U.S. Patent Application Serial No. 10/807,516
Amendment filed October 20, 2005
Reply to OA dated July 27, 2005

REMARKS

FIG. 9
PRIOR ART

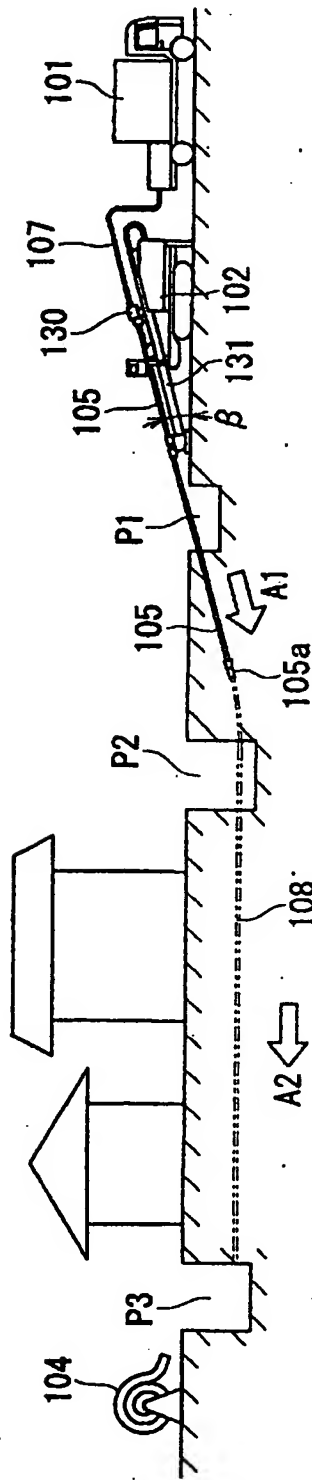
Also, the applicant submits herewith annotated and replacement sheets of drawings indicating that Figs. 9 - 11 illustrate conventional art by having Figs. 9 - 11 labeled as "Prior Art".
